ROUTE 7 CORRIDOR IMPROVEMENTS

State Project Nos.: 0007-029-942 and 0007-028-225
Federal Project Nos: STP-5A01(745) and STP-5A01(790)
Contract ID No.: C00099478DB98

VOLUME I: REVISED TECHNICAL PROPOSAL

Summary of Changes

STATE	FEDERAL AID	STATE	SHEET NO.
ROUTE	PROJECT	ROUTE	PROJECT
VA.		7	0007-029-942, B610

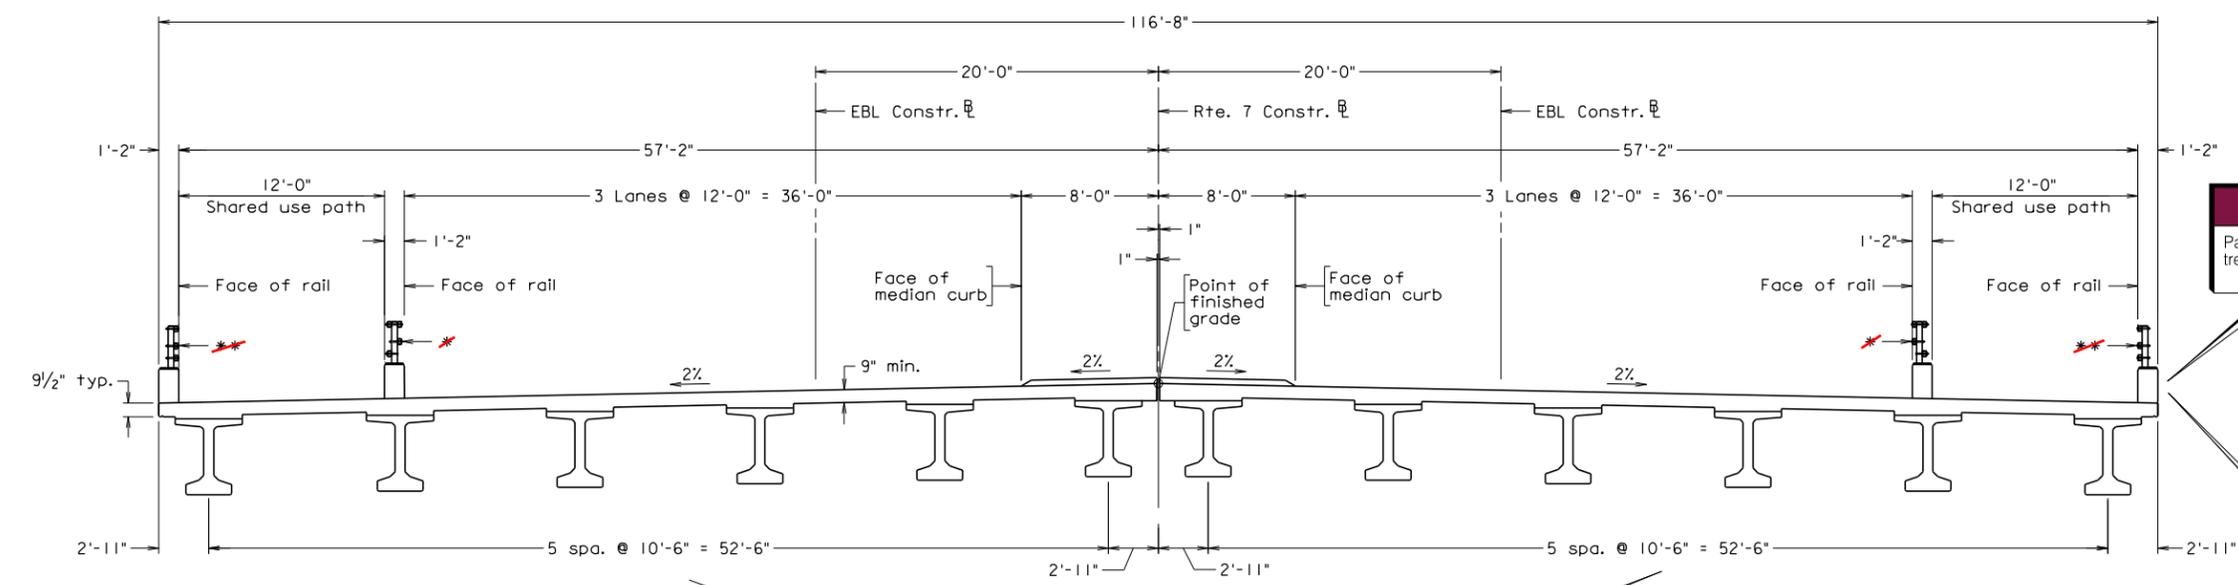
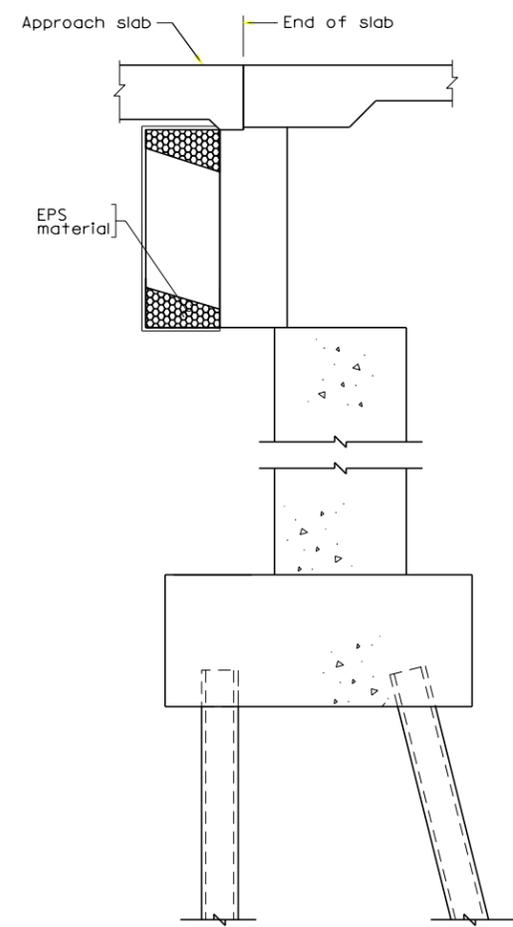
~~* 54"-BR27C Steel Railing, Std. BR27C-13 with simulated ashlar stone form liner on each barrier face.~~
~~** 54"-BR27C Steel Railing, Std. BR27C-14 with simulated ashlar stone form liner on each barrier face.~~

DESIGN ENHANCEMENT
 Reduced number of beams from 14 to 12 reduces maintenance, inspection and construction costs.

REVISED PROPOSAL DESIGN MODIFICATION
 Per Part 2, Section 2.3.4, BR27C-13 barrier will be replaced by CPSR-2 barrier and BR27C-14 will be replaced by CPSR-1 barrier on both sides of the bridge. Bridge will be widened by 8" (2" per barrier) to 117'-4" to accommodate the wider barriers.
